From: [Land Use Planning \(WorkSafe\)](#)
To: [Louise Hill](#)
Cc: [Joseph Thom](#); [Kerry K Greenfield \(DTP\)](#)
Subject: RE: Worksafe RFI for PA2403305 574 TARRONE NORTH ROAD TARRONE VIC
Date: Monday, 20 January 2025 3:30:41 PM
Attachments: [image004.png](#)
[image005.png](#)

From: Louise Hill <Louise.Hill@umwelt.com.au>
Sent: Tuesday, 10 December 2024 11:09 AM
To: Jodie D'Cunha (WorkSafe) <Jodie_D'Cunha@worksafe.vic.gov.au>
Cc: Joseph Thom <JThom@umwelt.com.au>
Subject: Worksafe RFI for PA2403305 574 TARRONE NORTH ROAD TARRONE VIC

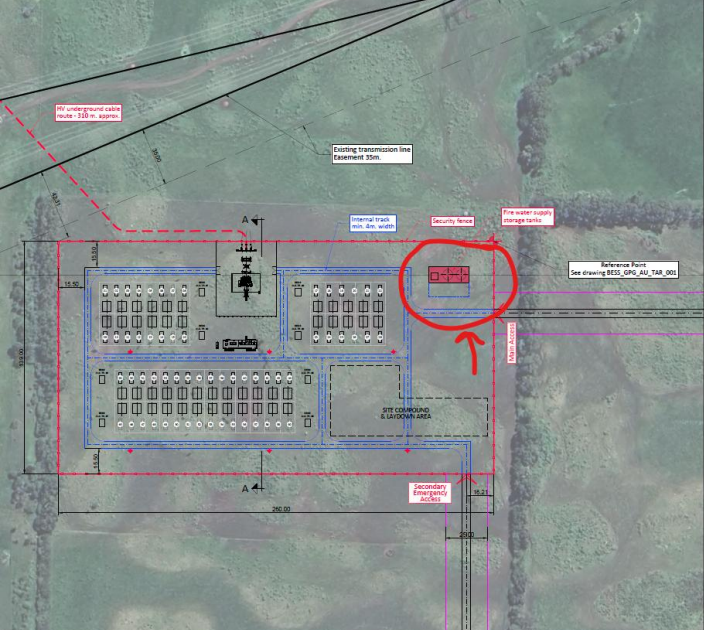
<p>If diesel will be stored onsite, what quantity and where will this storage be located onsite?</p>	<p>The transformers are dry type and therefore do not require the amount of diesel on site as previously stated in the Preliminary Hazard Assessment. As a result, we have updated the Preliminary Hazard Assessment to remove mention of that quantity of diesel being located on site, apart from a diesel generator (1,600 L) which is located next to the electrical building (shown below). The location of the diesel generator will be here:</p> 
<p>* Size of fire water supply storage tanks or proposed quantity of fire water. *</p>	<p>As stated in the bushfire assessment (July 2024), the fire water supply will meet CFA requirements and will be no less than 288,000L</p> <p>The location of the fire water supply tanks are located here:</p> 
<p>As per CFA recommendations in the Design Guidelines and Model Requirements – Renewable Energy Facilities” (CFA, Version 3 March 2022), "The fire water</p>	<p>The location of the fire water supply is located near the main entrance to the facility, the secondary access is an emergency access only and will not be used on daily basis. Early discussions were held with CFA with an older version of the site layout.</p>

supply must be located at vehicle entrances to the facility" – The current proposal locates the fire water tanks only at one entrance, not both. Has the applicant discussed the location of the fire water tanks with the CFA?

The location of the fire water supply tanks are located here:

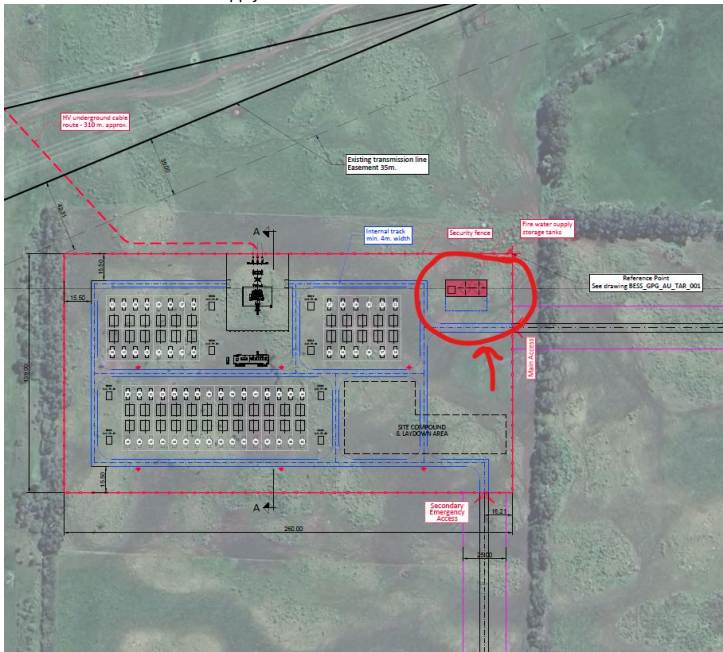
Please could you supply the current layout plan for the proposed site, which clearly identifies:

- where the fire water supply storage tanks are located (one map shows a central location, another shows a location near the main entrance)
- what quantity of diesel will be stored at each location (if multiple), and provide a map clearly identifying the diesel storage locations onsite

As a result, we have updated the Preliminary Hazard Assessment to remove mention of that quantity of diesel being located on site, apart from a diesel generator (1,600 L) which is located next to the electrical building (shown below).

The location of the diesel generator will be here:
